ADDENDUM NO. 001

RE: Sullivan County Department of Education – Emmett Elem. School Partial Roof Replacement
T&L Project No. 17117

DATE: March 3, 2023

1. Drawing Sheets A102 revised note.

1 ROOF EDGE DETAIL
A102

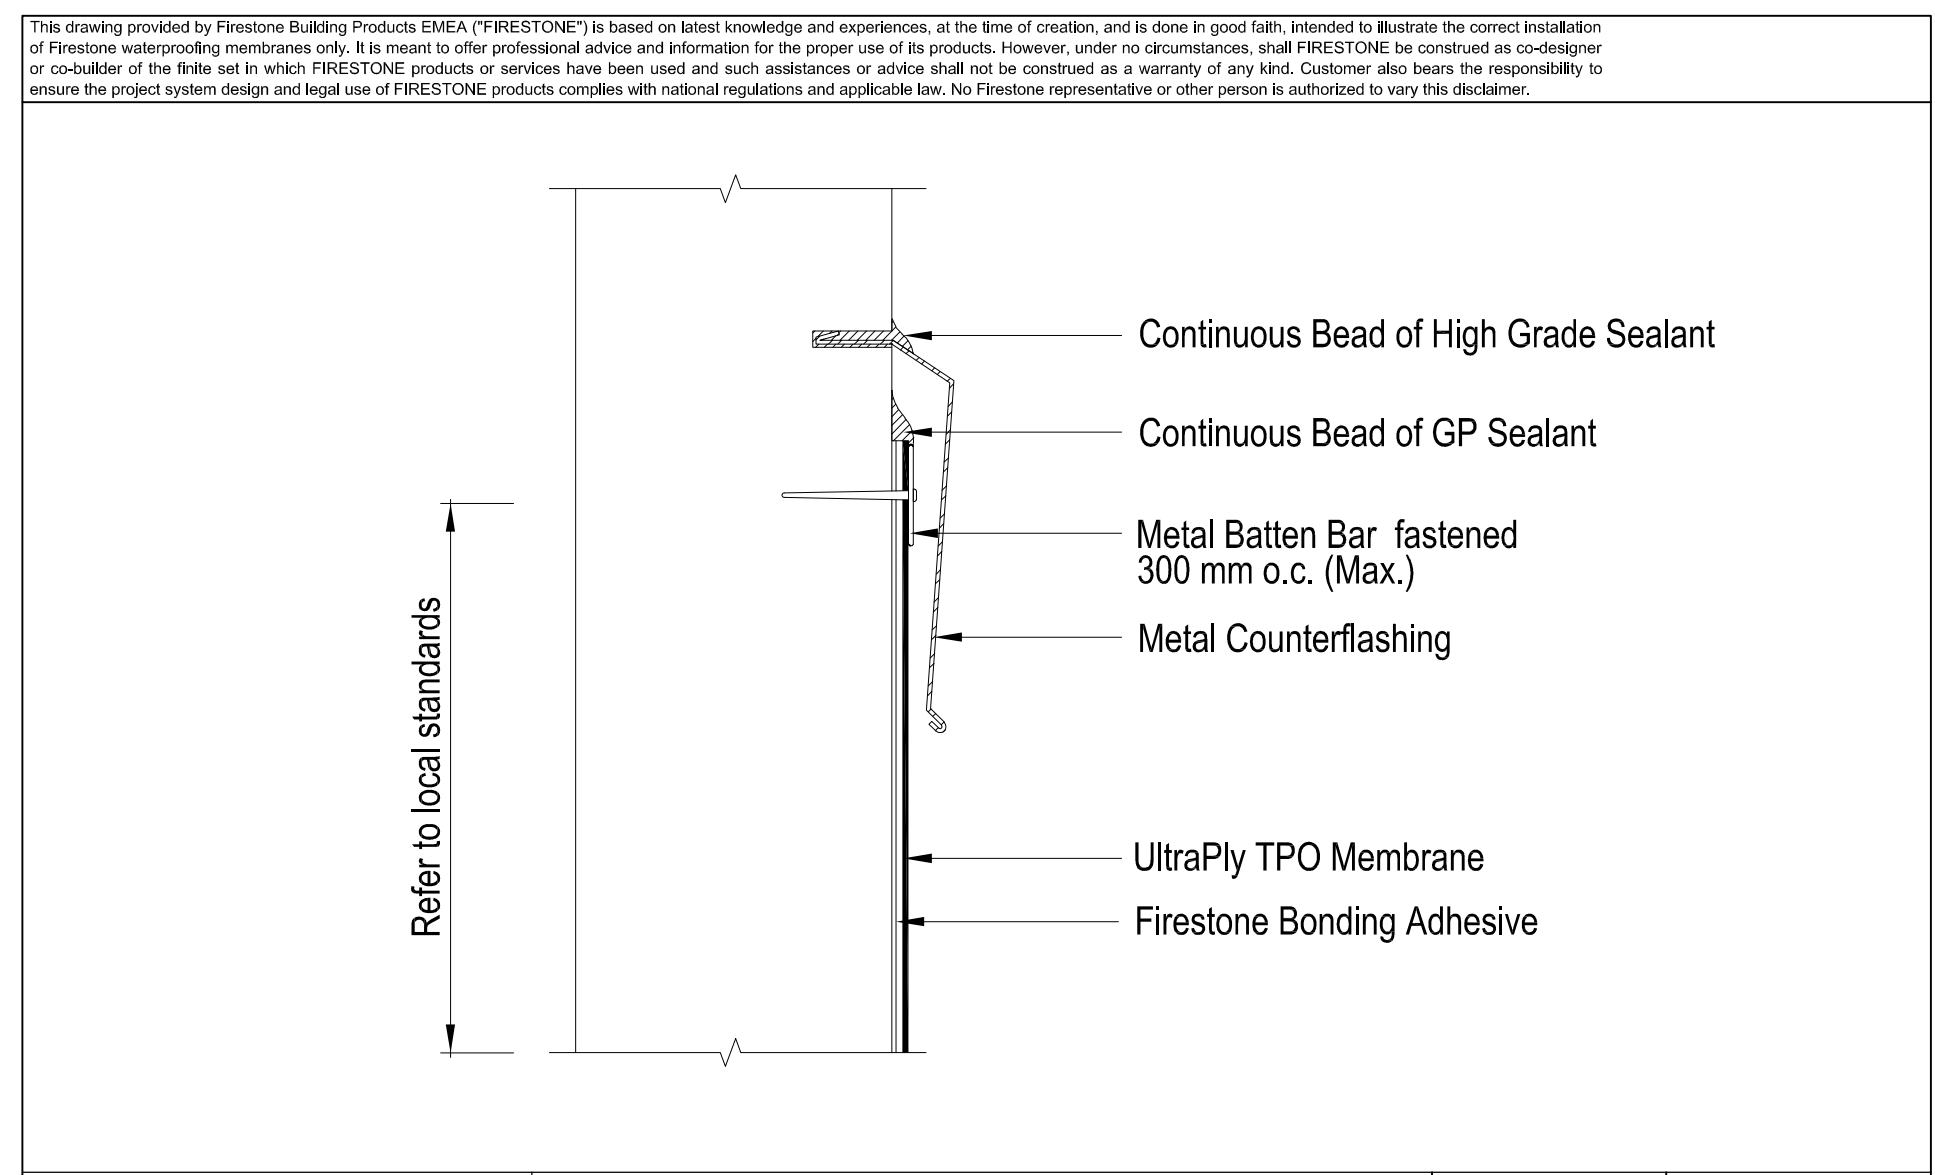
NOTE: PROVIDE BLOCKING FOR ROOF EDGE AS REQUIRED.

No.	1	Purpose of Document Issue	ADDED BLOCKING NOTE
Date	3/3/2023
